**RE: CITY OF SEAL BEACH COMMENTS ON DRAFT ENVIRONMENTAL IMPACT REPORT  
PREPARED FOR LONG BEACH SOUTH EAST AREA SPECIFIC PLAN**

Pursuant to Public Resources Code Sections 21091 and 21092, and California Environmental Quality Act (CEQA) State Guidelines Sections 15105 and 15087, this letter is written in response to the Draft Environmental Impact Report (SEIR), State Clearinghouse No. 2015101075, for the Southeast Area Specific Plan (SEASP) prepared by the City of Long Beach.

## Studebaker Rd and College Park Dr, Seal Beach

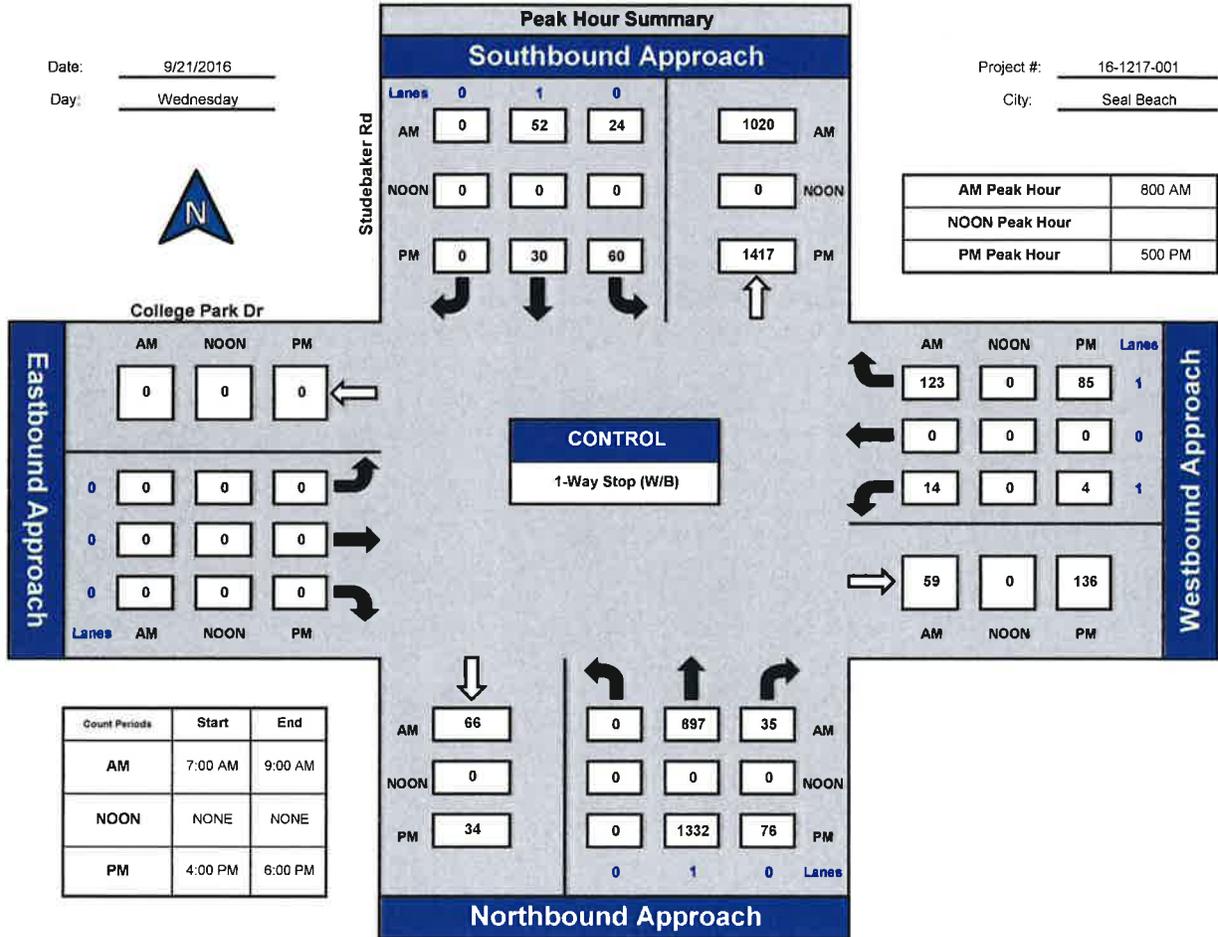
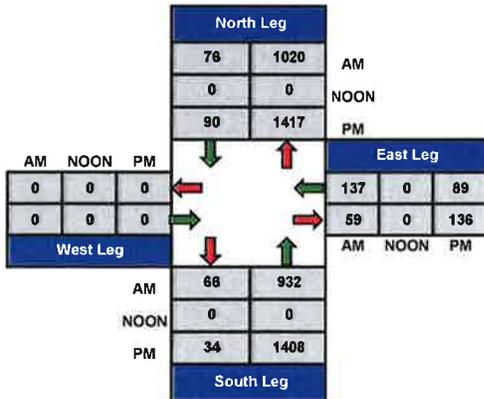
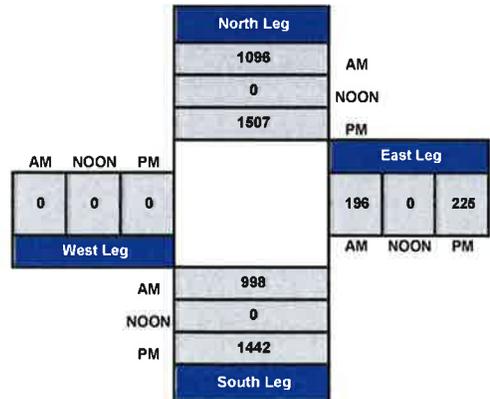
The SEASP area directly borders the City of Seal Beach and thus, has a high potential of impacting more than just the intersection studied at 2<sup>nd</sup> Street/Westminster and Seal Beach Boulevard. Pacific Coast Highway is a State Highway that runs through both the City of Long Beach and the City of Seal Beach. The DEIR identified that the intersection at Pacific Coast Highway and 2<sup>nd</sup> Street would be impacted by the proposed SEASP. The congestion caused at this intersection and along Pacific Coast Highway has a high potential of affecting traffic within the City of Seal Beach. Increased congestion at the Pacific Coast Highway and 2<sup>nd</sup> Street intersection could lead to increased congestion at the Pacific Coast Highway and Seal Beach Boulevard intersection. Similarly, the College Park Drive and 7<sup>th</sup> Street/22 FWY Westbound offramp intersection could be impacted by the proposed Project. The City of Seal Beach has already noted a pattern of vehicles that attempt to bypass Pacific Coast Highway by utilizing the Marina Bridge into the Long Beach Marina. For this reason, the intersection at Marina and 1<sup>st</sup> Street should be included in the traffic impact analysis.

The City of Seal Beach has included traffic information for these three intersections as an attachment to this letter. This information should be incorporated into the Final EIR analysis as well as in the Mitigation Monitoring and Reporting Program. Level of Service calculations must be analyzed for each intersection based on the City of Seal Beach's Traffic Impact Study Guidelines, also attached for your reference.
